**STAFF REPORT**  
(One-Step Final Plat)

**CASE NUMBER:** SUB 2001-62 -- MANNIS ADDITION

**LOCATION:** East side of 327th St. West, South of Pawnee

**VICINITY MAP**

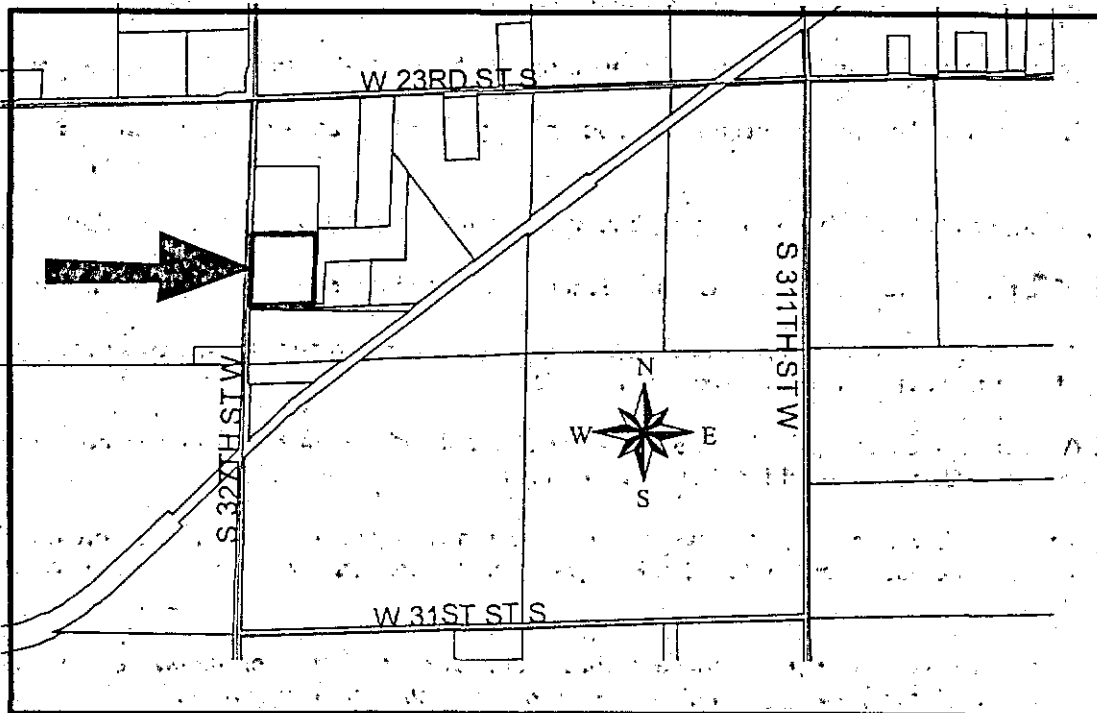
Note: This site is located in the County in an area designated as "rural" by the 1999 Update to the Wichita-Sedgwick County Comprehensive Plan. It is located in the Garden Plain Area of Influence.
